# Authorized Field Change

**AFC 04905**

**Subject:** 9000i Models Built at the Escobedo Assembly Plant, Between August 1, 2002 and February 12, 2004, with Post 2002 Emission Cummins ISM Engines have the Heater Piping Mounting Bracket Mislocated on the Engine

Truck Model: 9000i

**Figure 1 Relocate Bracket to Hole 2**

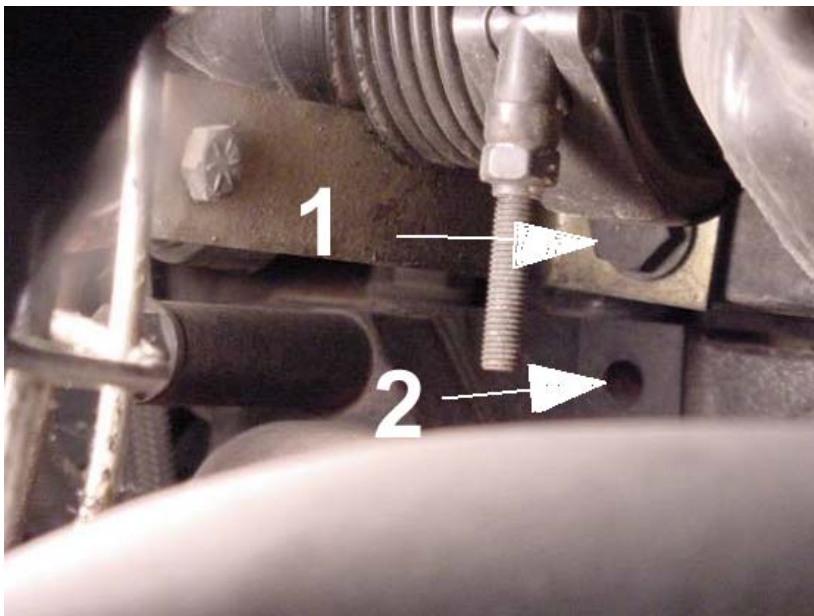
9000i Models built in Escobedo have the heater piping bracket mounted to the engine valve cover instead of the engine block. When the bracket is mounted to the engine valve cover, the bracket may contact the EGR pipe and may result in a failure of the EGR pipe bellows and exhaust leakage.

1. Locate the heater pipe mounting bracket (Figure 1), remove the mounting bolt and relocate the mounting bracket and mounting bolt to the lower hole as shown in Figure 1, Item 2.

1. Valve Cover Hole
2. Correct Hole in Engine Block

**Figure 2 EGR Connector Pipe Bellows Shown at Arrow**

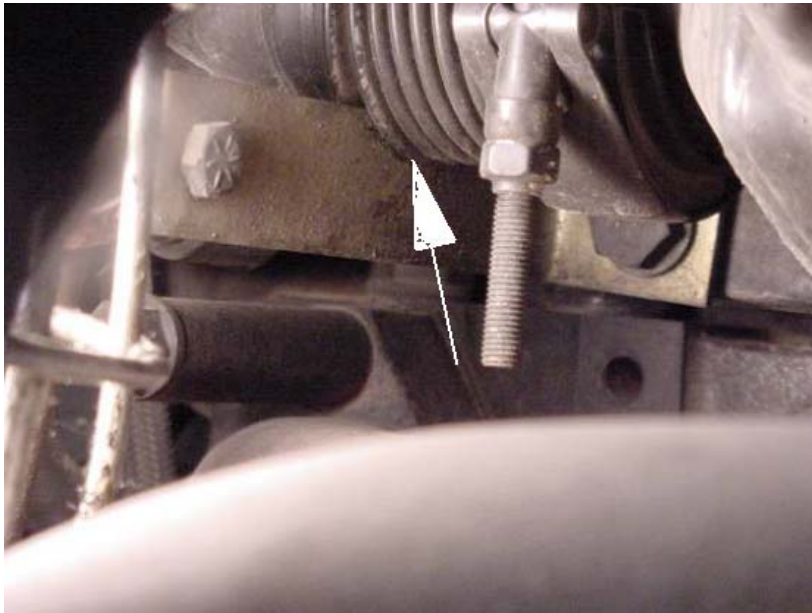
2. Inspect the bellows of the EGR connector pipe for evidence of contact with the heater pipe bracket (Figure 2).
  - A. If there is no evidence of contact, the EGR connector tube does not need to be replaced.
  - B. If there is evidence of contact between the heater pipe bracket and the EGR connector pipe bellows, the EGR connect pipe needs to be replaced. Continue to the next Step.

**Figure 3 EGR Connector Pipe Removal**

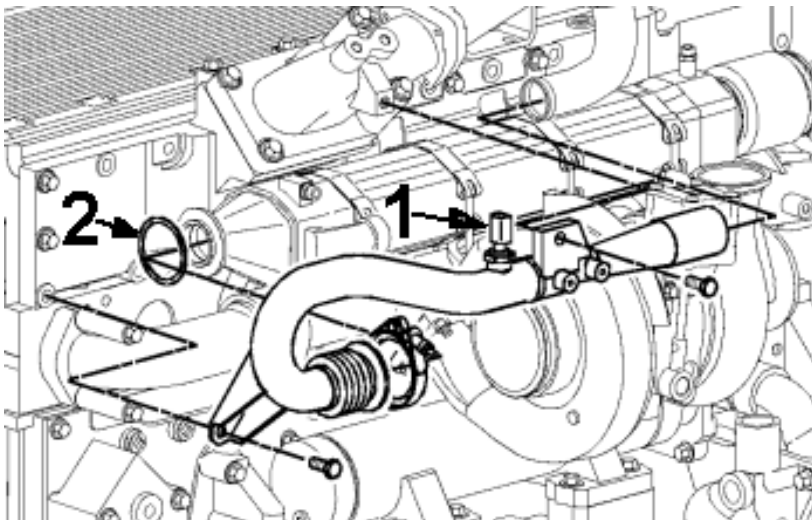
3. Remove the EGR connector pipe fasteners, clamps, sensor, seal, and EGR pipe as shown in Figure 3. Retain the fasteners, clamps, sensor, and seal for reuse.

**Figure 4 Tighten Fasteners and Clamps**

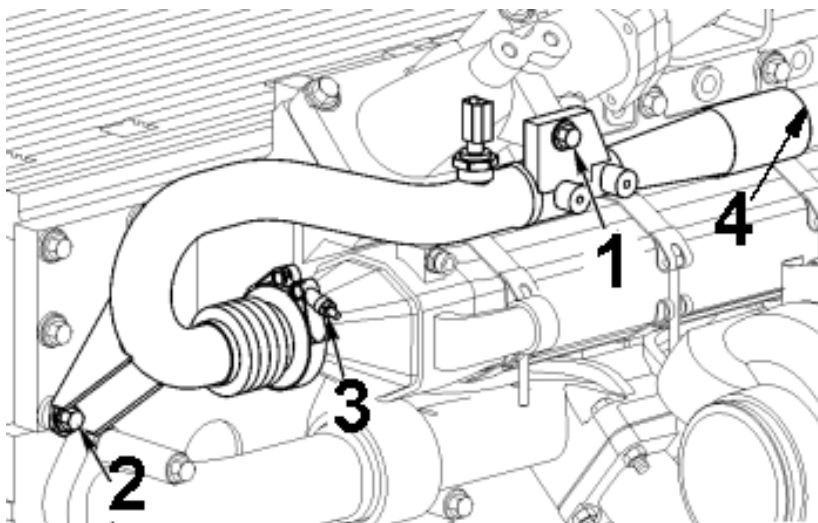
4. Install new EGR Connector pipe. Refer to Figure 4 and Table 2.

Figure 4 Item Number	Torque Specification
1	32 to 39 Lbf-ft (43 to 53 Nm)
2	32 to 39 Lbf-ft (43 to 53 Nm)
3	135 to 165 Lbf-in (15 to 19 Nm)
4	54 to 75 Lbf-in (6 to 8 Nm)
